## DETAILED ACTION

Art Unit: 2832

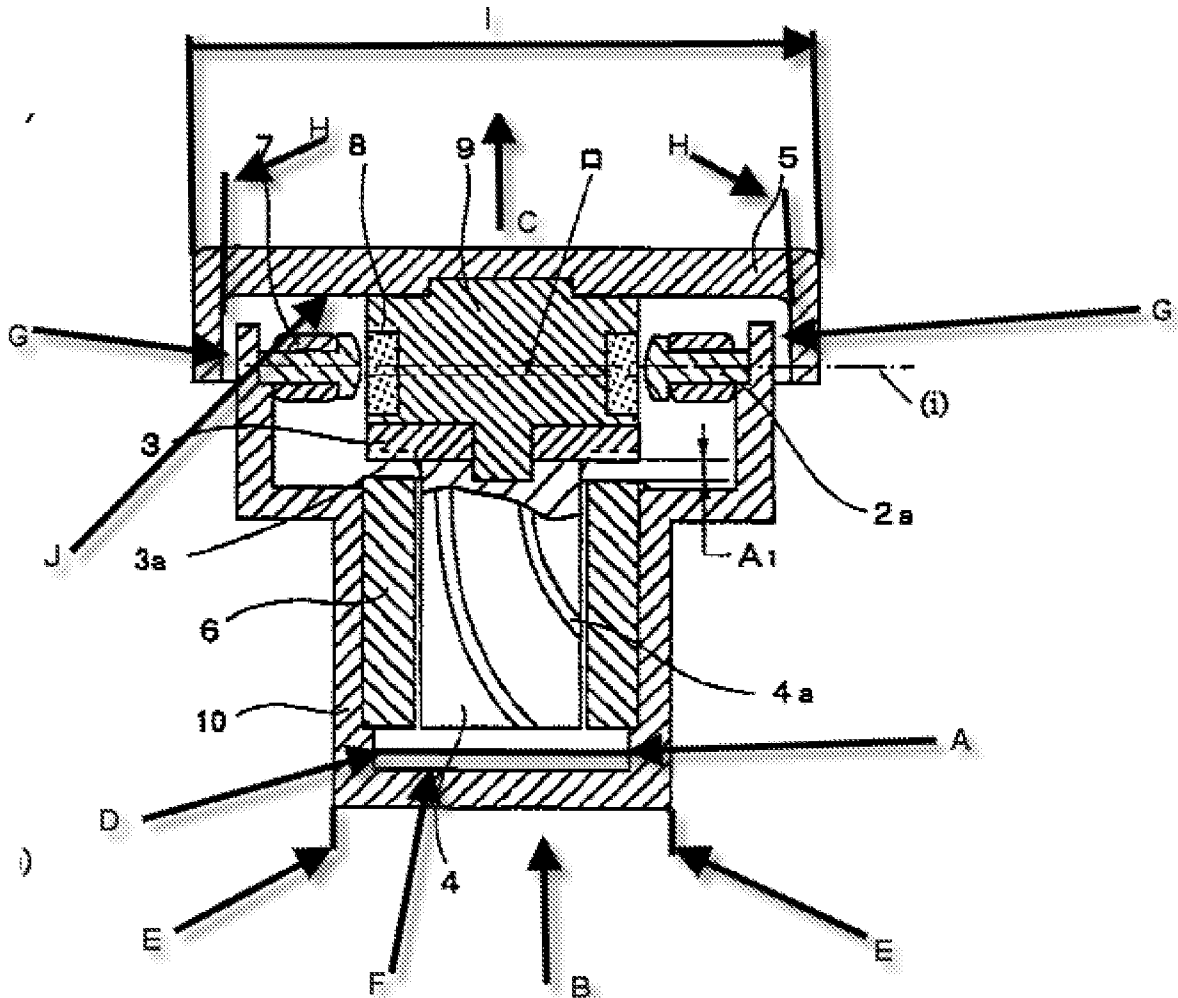
20. Regarding **claim 14**, at **[figs. 2a/2b and the annotated drawing in page 11] Komura** teaches a first can **[10]** comprising a first continuous can member **[10]** comprising a first sidewall **[A]** circularly symmetric about and extending along a first axis **[B]**, having an inner first diameter **[D]** and an outer second diameter **[E]** differing there between by twice a first wall thickness, and a first end **[F]** extending transversely to the first axis **[B]**, having a first end thickness, and connected to the first sidewall **[A]**; and a second can **[5]** comprising a second continuous can member **[5]** comprising a second sidewall **[G]** circularly symmetric about and extending along a second axis **[C]** disposable along the first axis **[B]**, having an inner third diameter **[H/H]** and an outer fourth diameter **[I]** differing there between by twice a second wall thickness, a second end **[J]** extending transversely to the second axis **[C]** and connected to the second sidewall **[G]**, and a third sidewall **[J]** circularly symmetric about and extending along the second axis **[C]**, having an inner diameter **[H/H]** larger than the second diameter **[E]** by a first clearance **[HE]** and an outer sixth diameter **[I]** greater than the fifth diameter **[H/H]** by twice a third wall thickness, and connected to the second sidewall **[G]** on a side thereof opposite the second end **[J]**; whereby the third sidewall is slidable over a radial outside of the first sidewall **[fig. 2a]** so that
